Office Action Summary	Application No. 10/790,691	Applicant(s) MIDDLETON, DAVID GRANT	
	Examiner Robert J. Popovics	Art Unit 1724

DETAILED ACTION

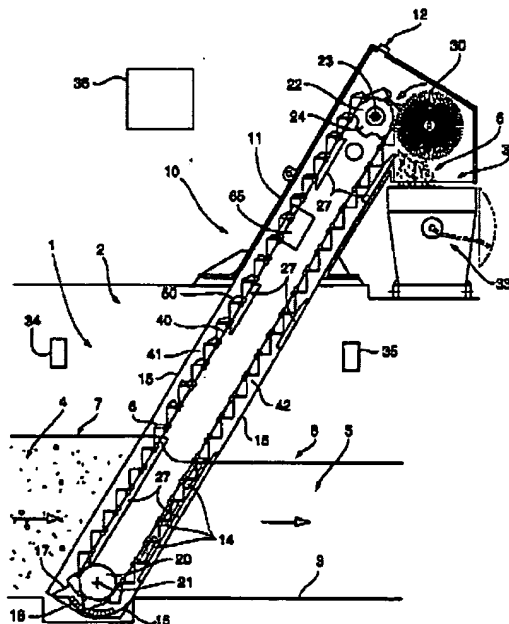
Claims 3-5 and 13-15 are rejected under 35 U.S.C. 103(a) as being unpatentable over **Larsen (US 5,800,701)**. Claims 3-5 and 13-15 essentially differ from **AAPA** by specifying a rotary brush or cleaning device. Larsen discloses the use of a rotary brush to clean an endless screen:

In view of this disclosure, it would have been obvious to one of ordinary art to employ a rotary brush in the system described by AAPA, in order to aid in the cleaning of the screen.
